Subject: **COLUMBIA GENERATING STATION, DOCKET NO. 50-397  
RESPONSE TO REQUEST FOR ADDITIONAL INFORMATION  
LICENSE RENEWAL APPLICATION**

**RESPONSE TO REQUEST FOR ADDITIONAL INFORMATION**

**RAI B.2.31-1**

**LICENSE RENEWAL APPLICATION**  
**AMENDMENT 42**

Figure 1: Droplet fallout settling on transformer yard

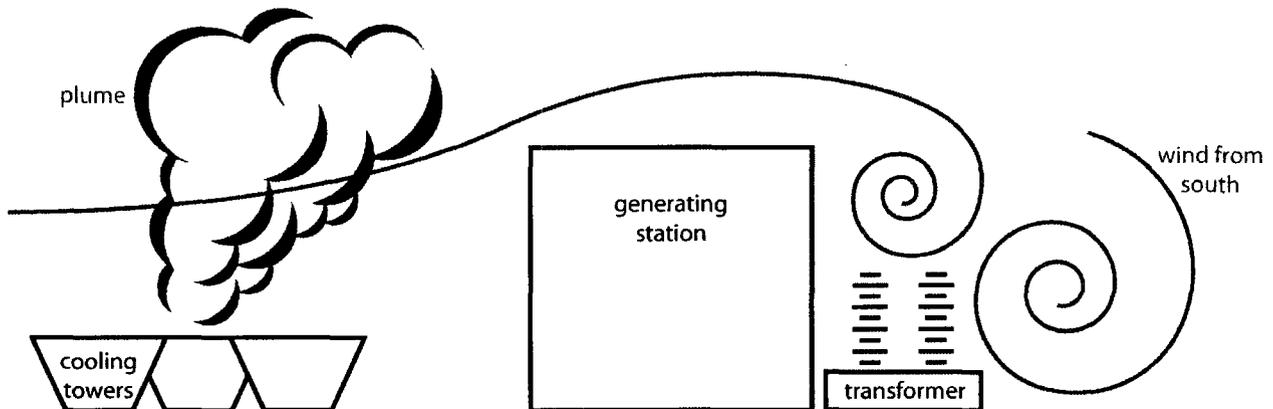
Explain why the high-voltage post insulators at the 230kV ASHE A809 Breaker located in the ASHE Substation are not subject to circulating water system cooling tower spray drift and do not require a coating or cleaning aging management program.

quarter mile north of the main plant. As the drift droplets move northward towards the plant, wind dynamics experienced, as the droplets are carried over the generating station, force much of the droplets down onto the transformer yard, thus making this area the most vulnerable to scintillation. Figure 1 illustrates the effect.

Under worst-case conditions, the drifting droplets created conditions conducive to arcing in the station's transformer yard. This arcing occurred when a sufficient layer of conductive substances built up on the insulators, became wetted, and formed an electrical track. Columbia Generating Station collects its cooling water from the Columbia River, which it then buffers with various chemicals to temper the water for use in the plant. Thus, the substances found in the drift droplets of the cooling tower are chemical species found naturally in the river, those added to buffer the water, those that form from decomposition of original buffers, and trace minerals and metals from the cooling system. The result is a layer of anions and cations that once settled on the surface of insulators present a prime opportunity for insulator failure.

Based on the above, the 230 kV station post insulators at Ashe were not included in the High-Voltage Porcelain Insulators Aging Management Program.
